Addendum #1

Attn: Estimator	Date: November 14, 2024
From: Lisa Donahue, Project Administrator	Pages: 58 (including cover page)
Re: Bullock Creek School District 2024 Bond Series 1	Project: 2025 Summer Projects HS/MS/Elem/Pine River/Floyd and Maintenance Building
CC:	Proj. #: A24907

Project: No. 24-120 2023 Bond – Series 1 2025 Improvements

Issue Date: November 14, 2024

1/4" = 1'-0" X01

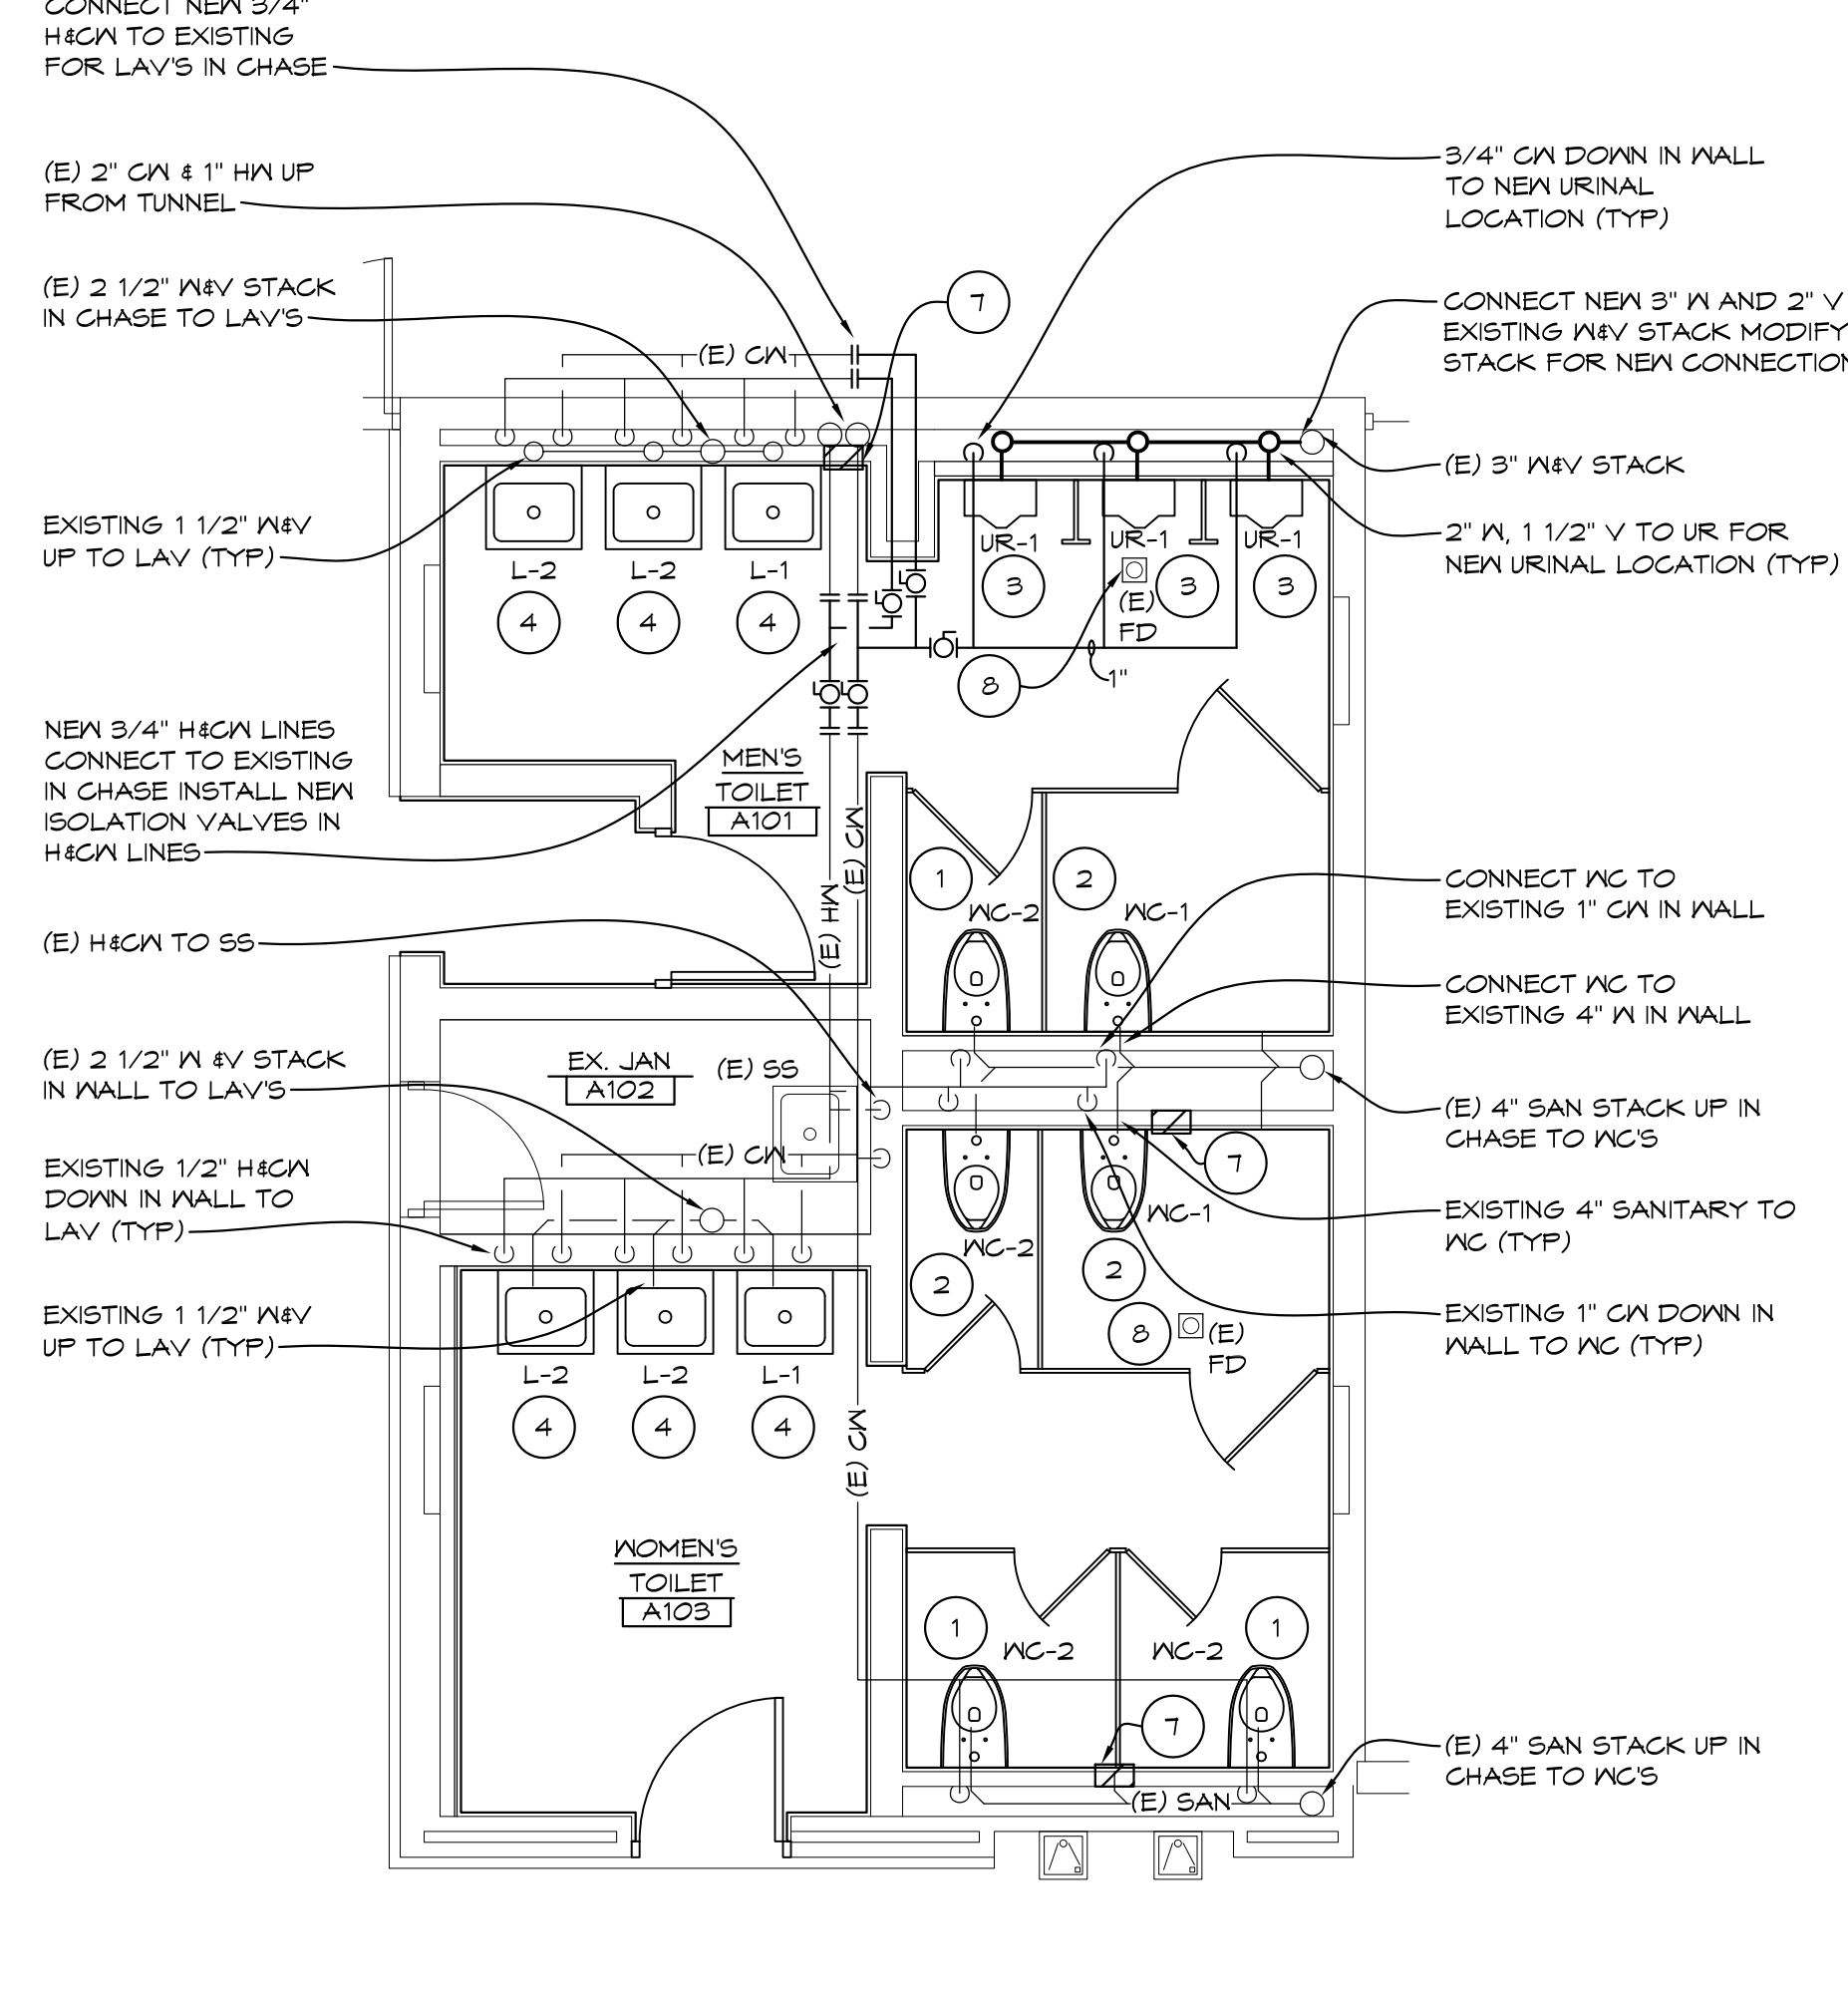
Item #P3: Revise Sheet A-P103 as follows:
a. Revise plumbing for 'D' wing toilet room D101. See piping revisions along with installation of isolation valves in ceiling space in lieu tunnel space.
b. Updated sheet count

DEMOLITION COOLER PLAN
1/8" = 1'-0" X01

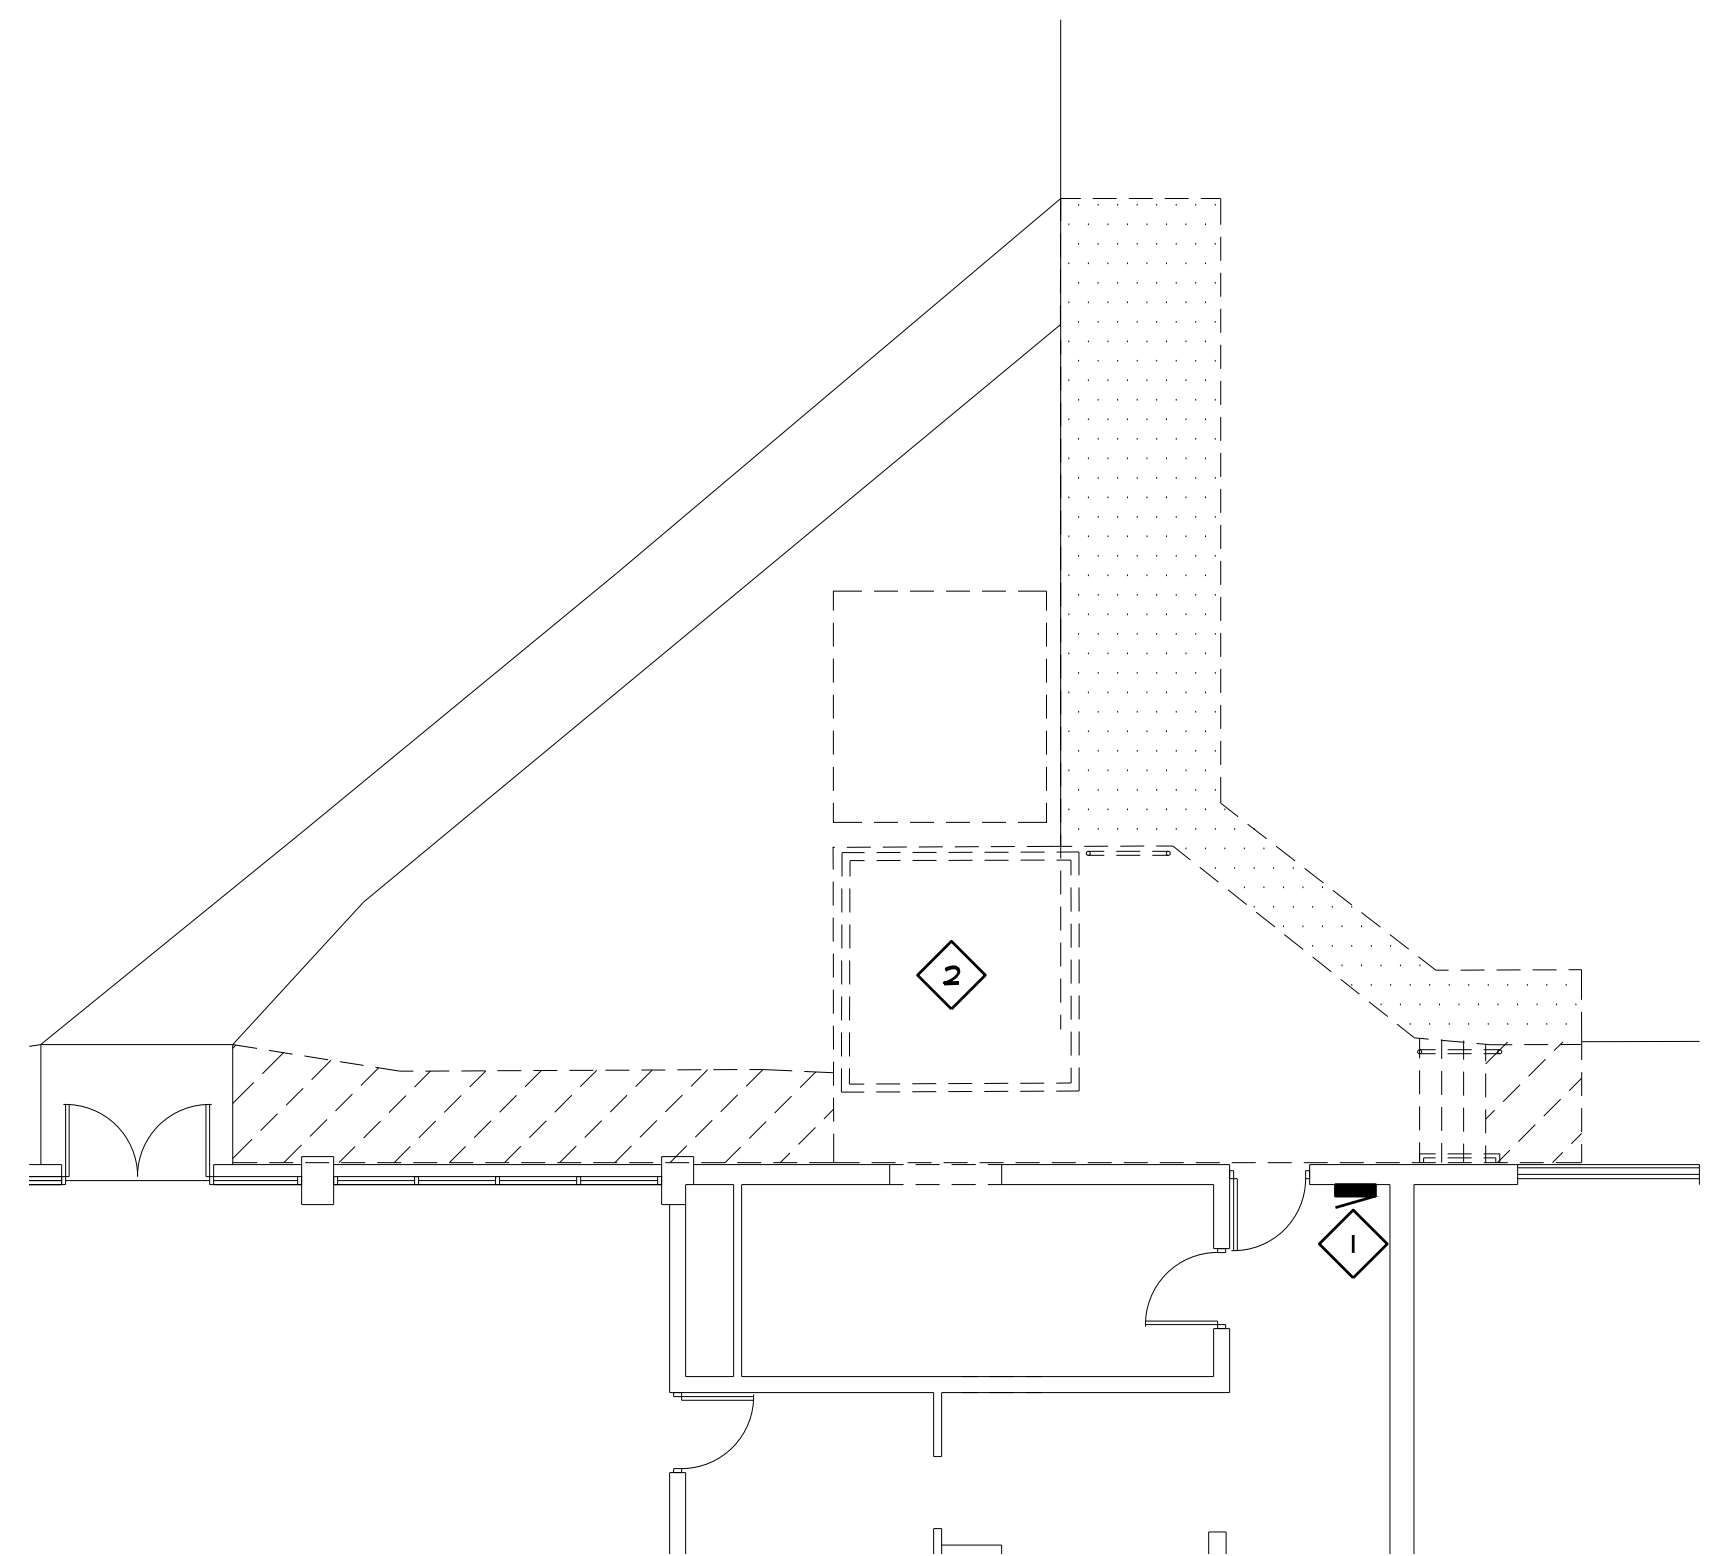
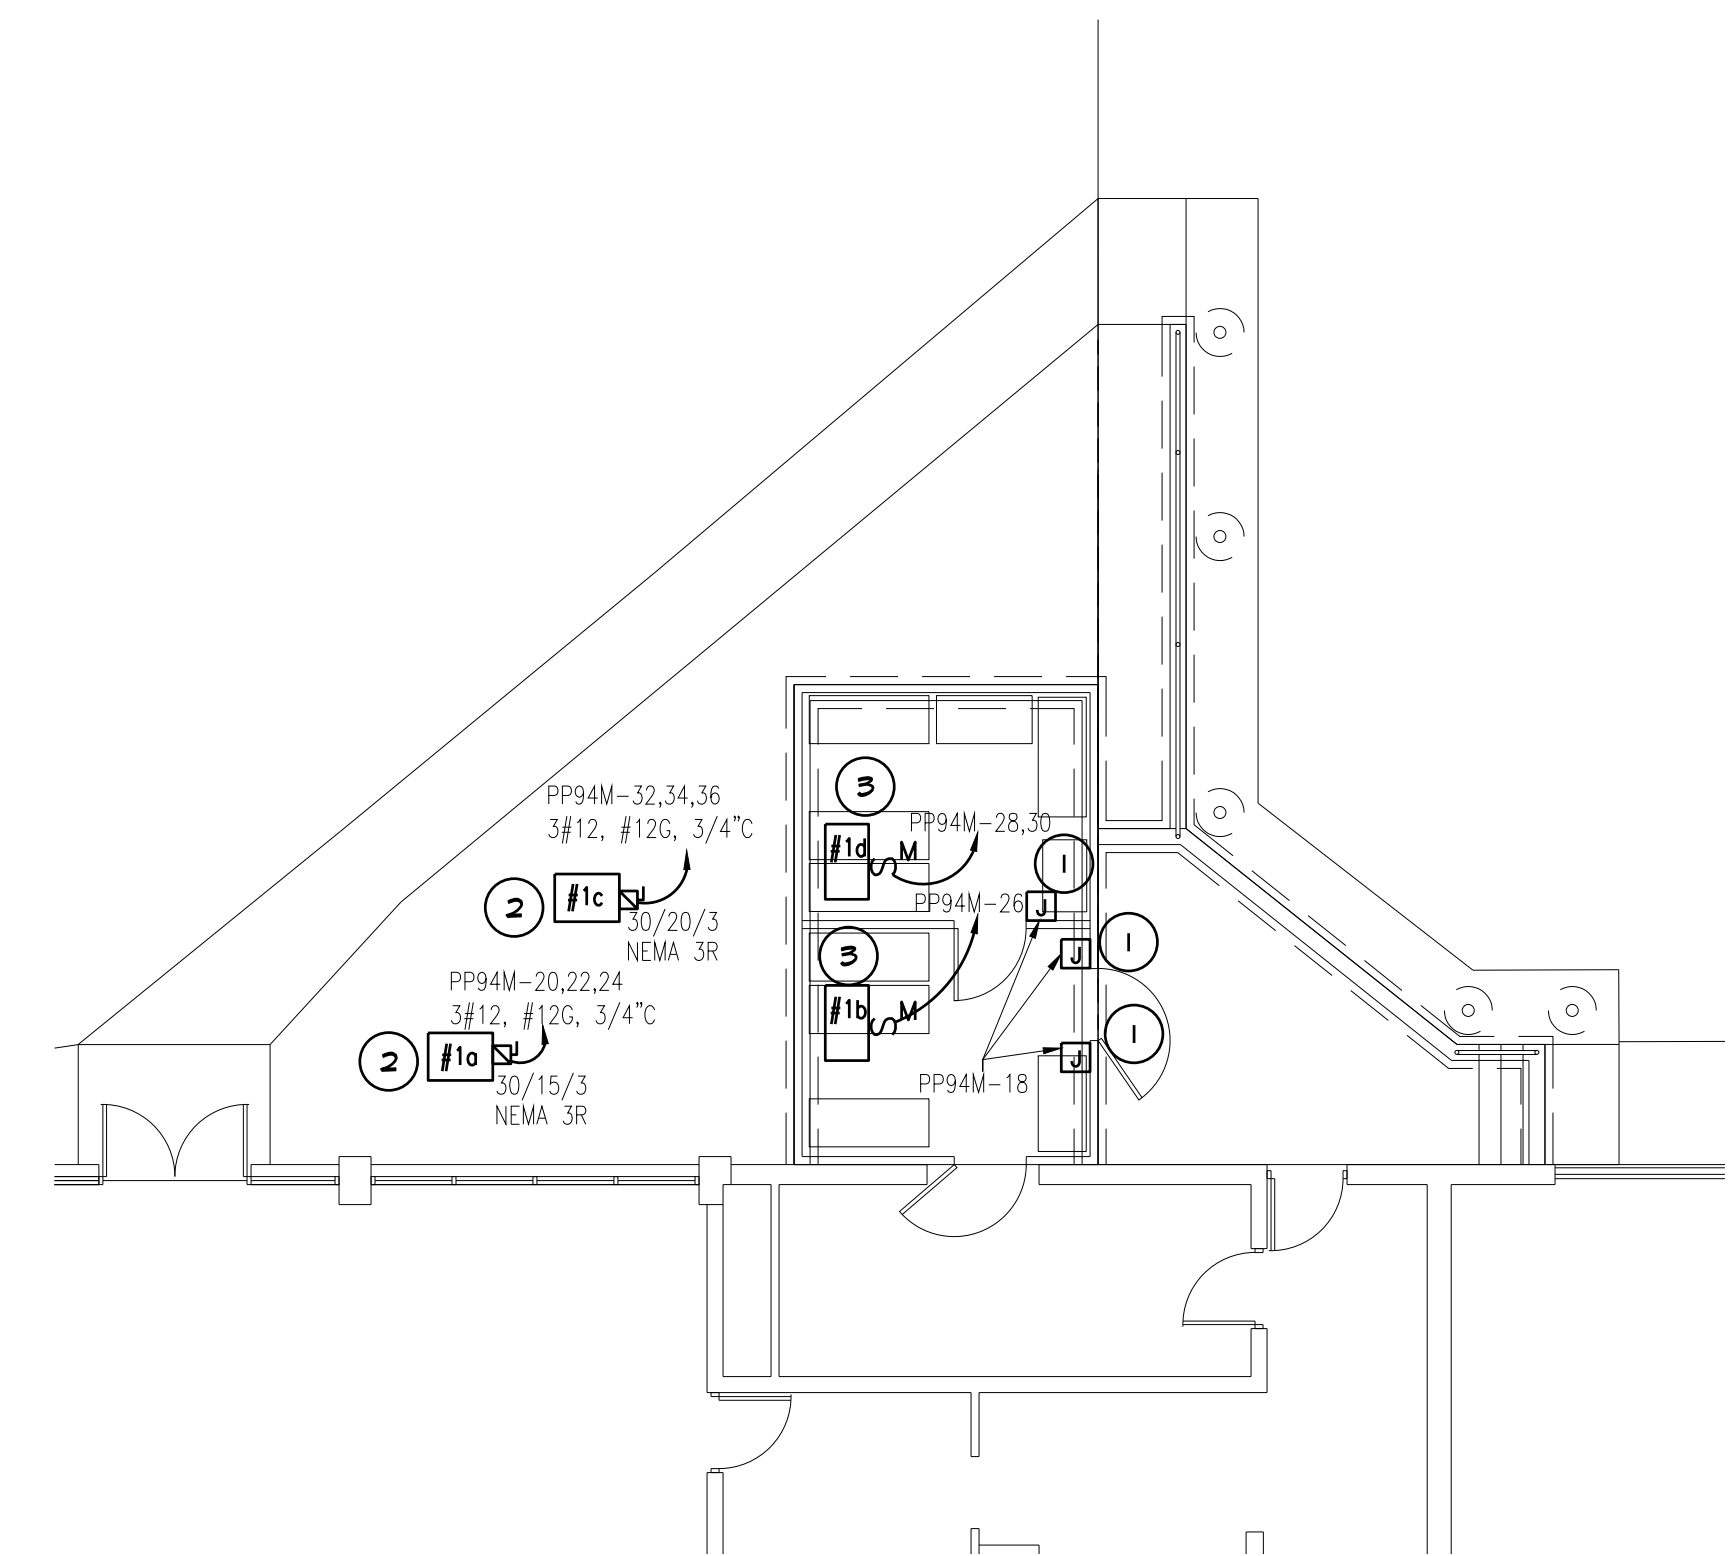
- Item #A1: Revise Sheet B-A102 as follows:
- a. Demolition Note 7 revised to “existing cooler to be removed by others.”
 - b. Additional wall section tag added.
 - c. Removed demolition of existing wall.
